## DEVELOPMENT REVIEW BOARD

### DEVELOPMENT REVIEW BOARD STAFF REPORT

<b>Hearing Date:</b> April 28, 2016	
<b>Case No:</b> DRB 2016-17	
<b>Application(s):</b> Conditional Use	
<b>Application Received:</b> March 15, 2016	
<b>Application Deemed Complete:</b> March 15, 2016	
<b>Staff Report Finalized:</b> Friday, April 21, 2016	
<b>Applicant(s):</b> Jack Milbank Civil Engineering Associates 10 Mansfield View Lane South Burlington, VT 05403 <a href="mailto:jmilbank@cea-vt.com">jmilbank@cea-vt.com</a> 802-864-2323 x315	<b>Owner(s):</b> Justin and Betsy Wheating 1225 Harvey Farm Road Waterbury Center, VT 05677 <a href="mailto:jpm@nrgsystems.com">jpm@nrgsystems.com</a> 802-503-5833
<b>Engineer/License:</b> Jack Milbank Civil Engineering Associates	<b>Surveyor/License:</b> None
<b>E-911/Postal Address:</b> 304 Cold Spring Road	
<b>Tax Map, Parcel(s):</b> 9, 13-105	
<b>School Parcel Account Number(s) (SPAN):</b> 13769	
<b>Deed(s):</b> Book 166, Page 209	
<b>Existing Size:</b> 1.3 acres

**Noticed/Warned Summary of Proposal:** Justin & Betsy Wheating, Owners/Jack Milbank - Civil Engineering Associates, Applicant, request Conditional Use approval to repair and replace a failed retaining wal

**PROPOSED CONDITIONS SITE PLAN**

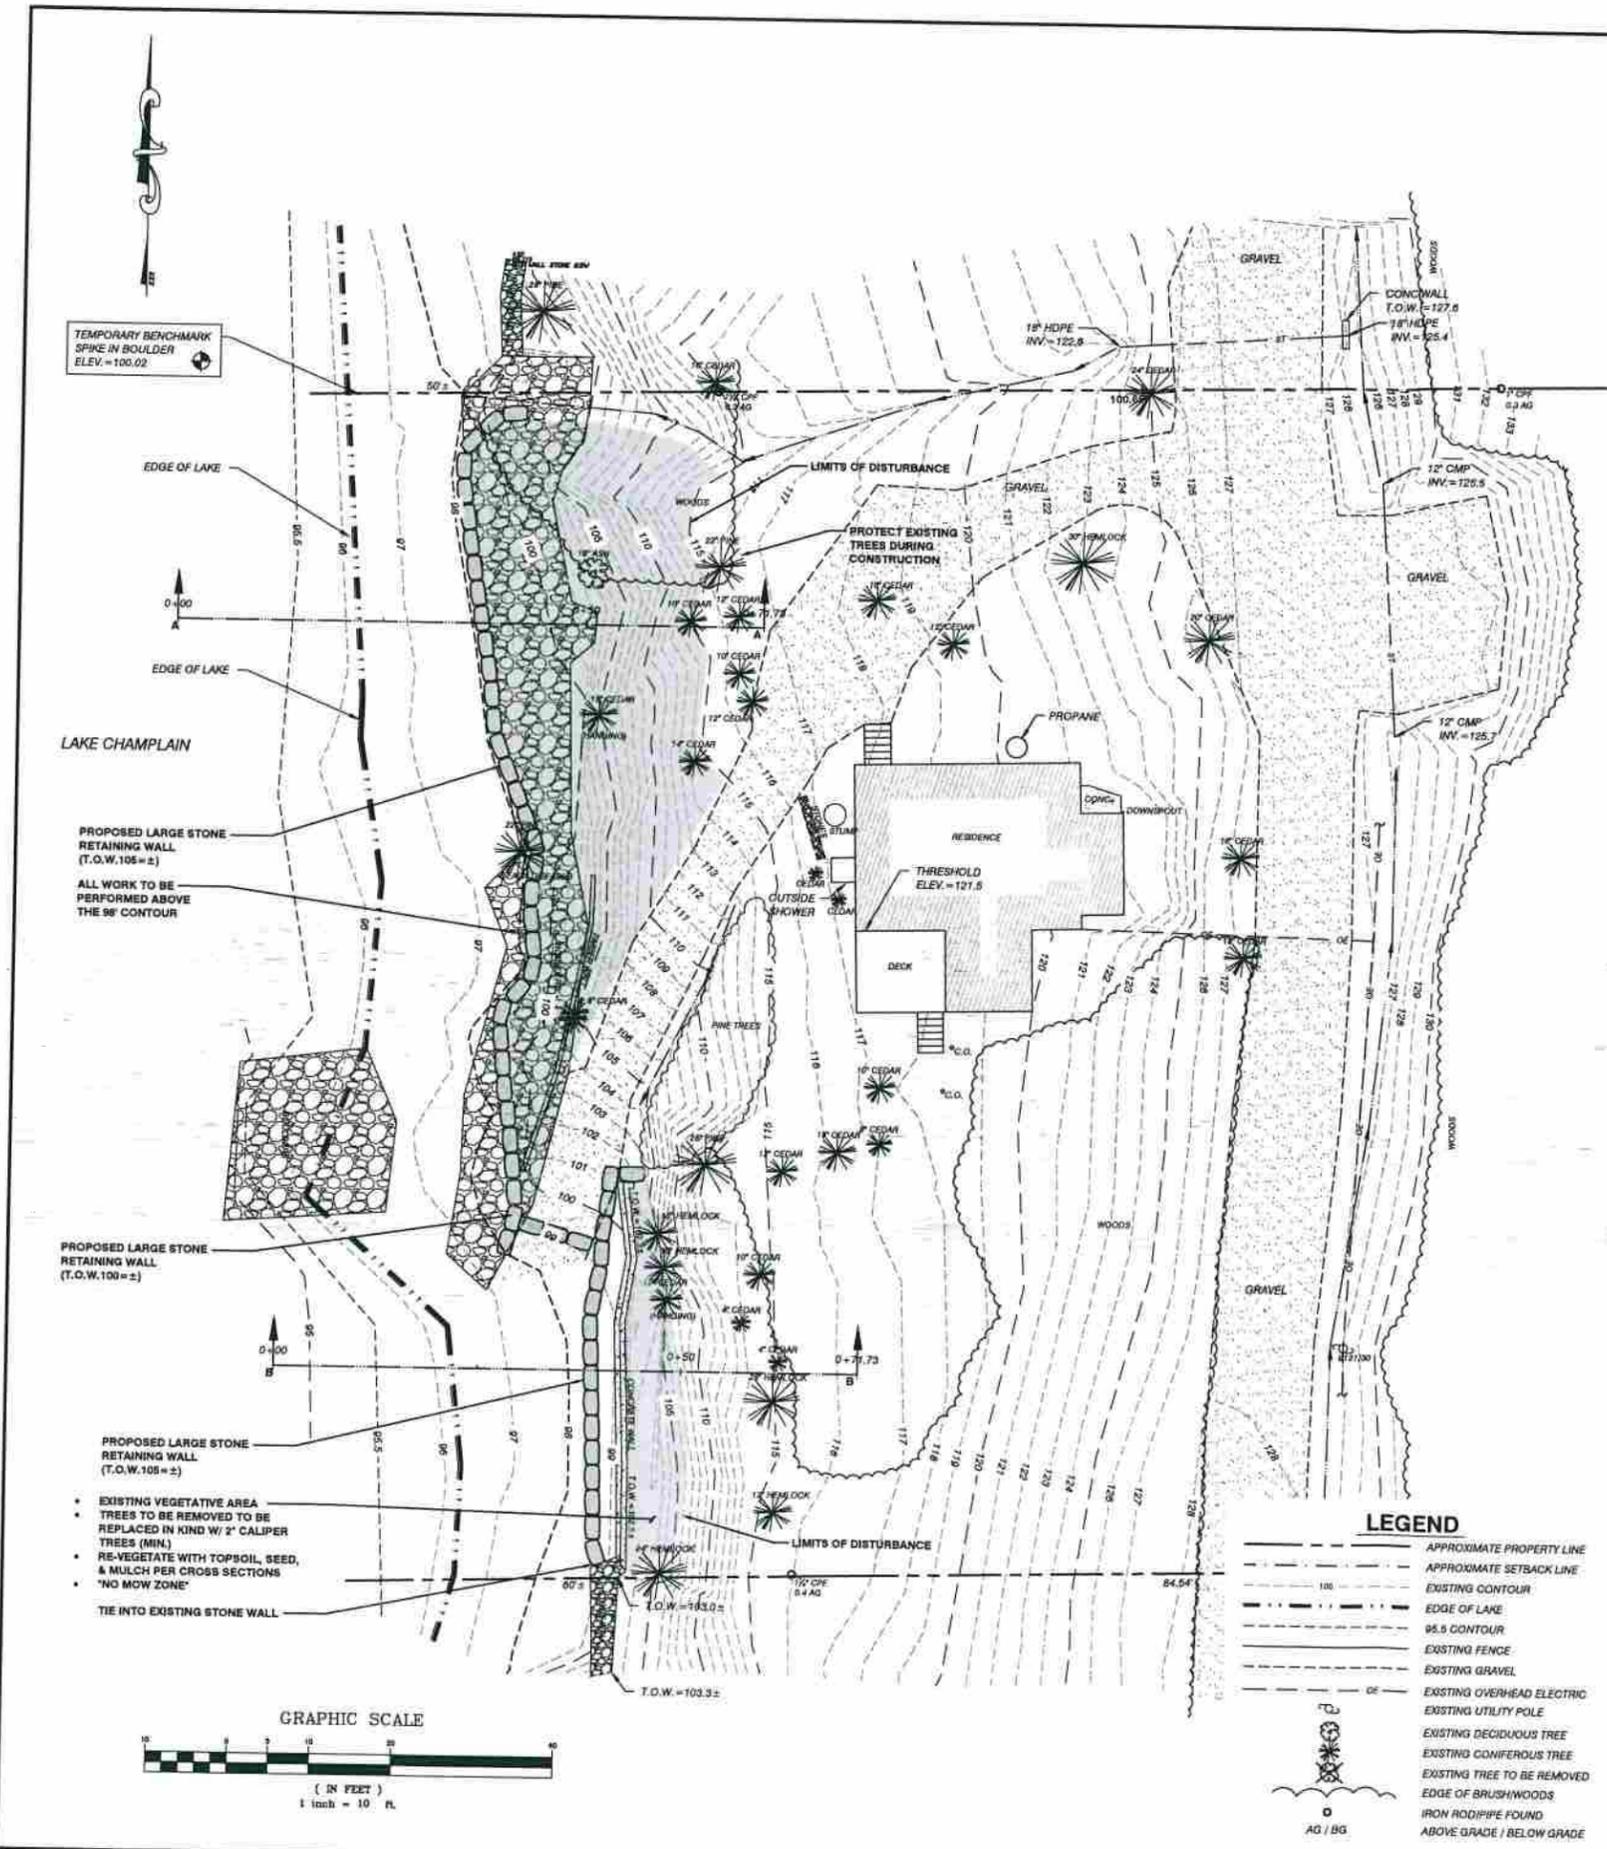
2. The applicant should clarify how many trees are to be removed and replaced within 25 feet of the shoreline.

**PROPOSED CONDITIONS SITE PLAN**

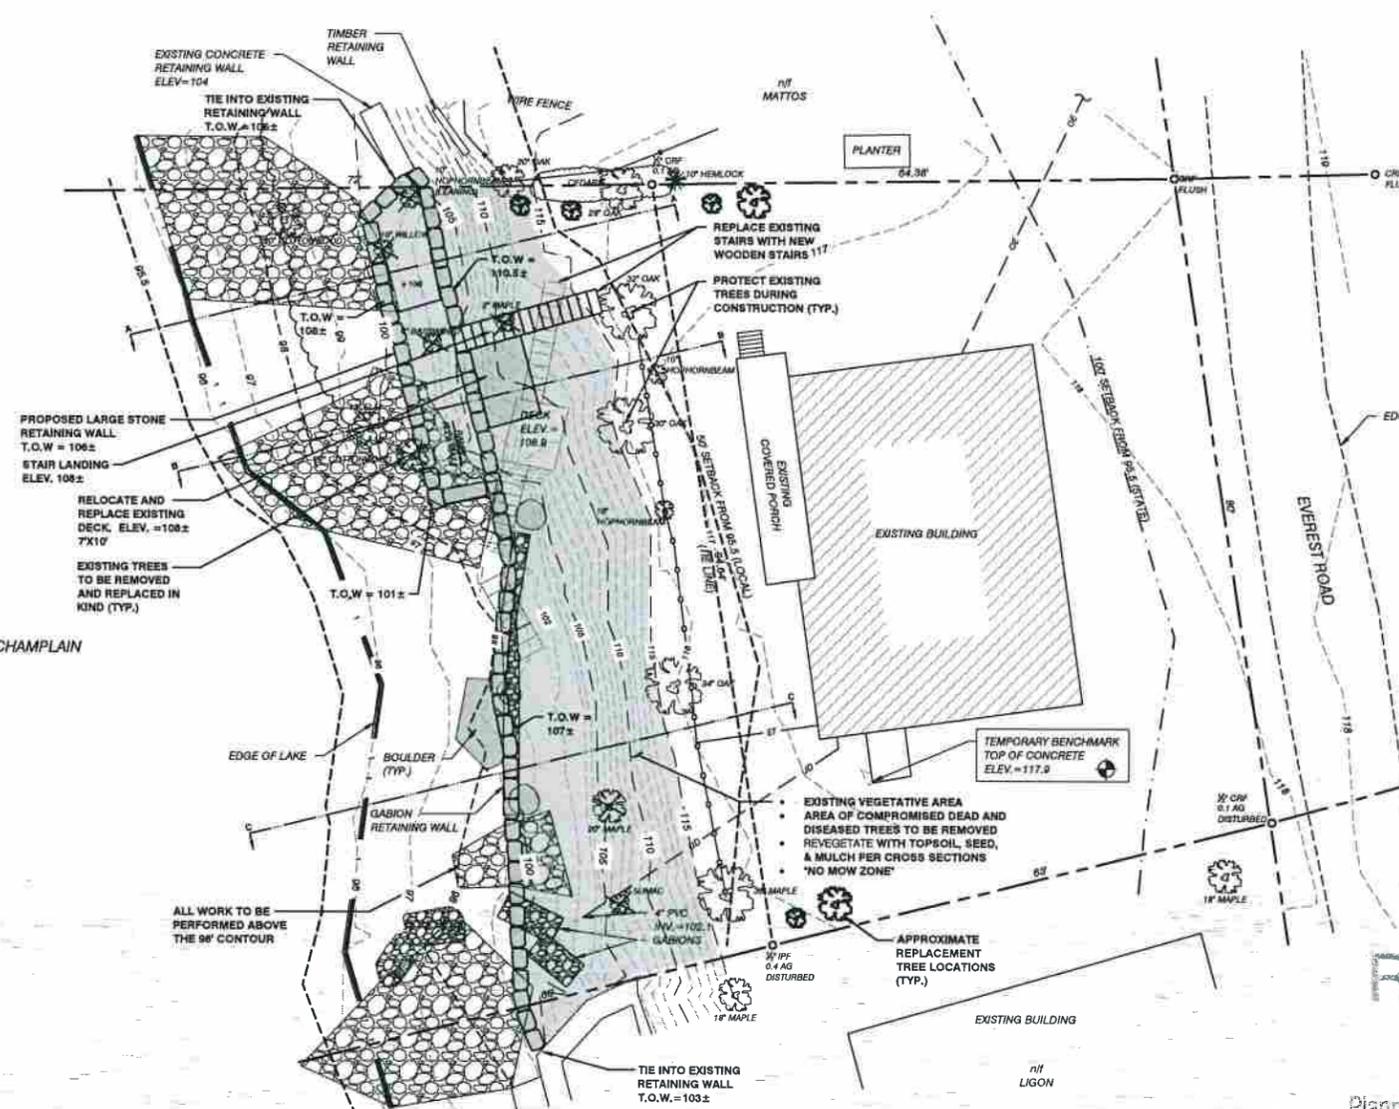
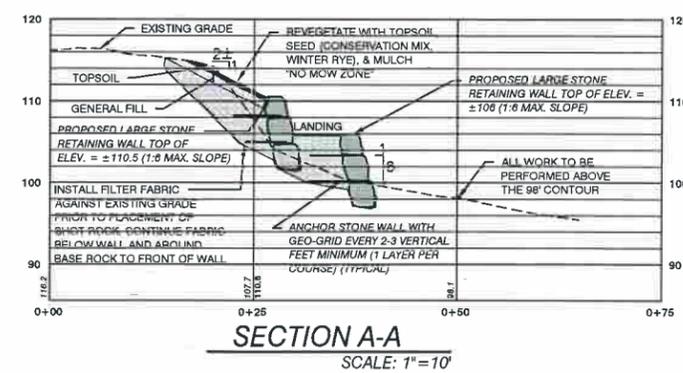
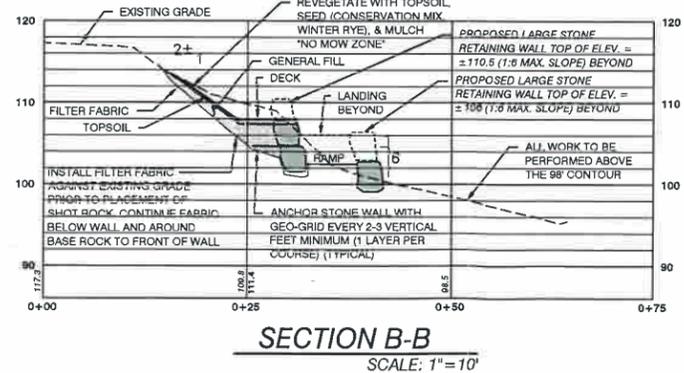
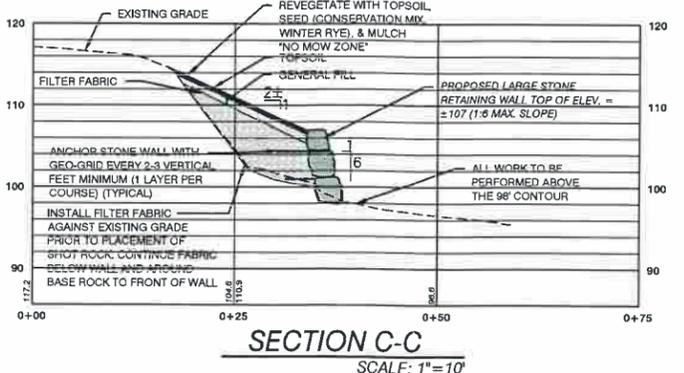
2. The proposed deck shall not further encroach on the shoreline setback of 50 feet or the side setback of 35 feet and shall not increase in area from the existing deck. The existing and proposed deck dimensions and distances to setbacks shall be indicated on the final plans.

3. The applicant should clarify how many trees are to be removed and replaced within 25 feet of the shoreline.
4. Trees and groundcover shall be restored such that there is no more than a 25% reduction in trees and /or ground cover within 25 feet from the shoreline, per ZR356.1.
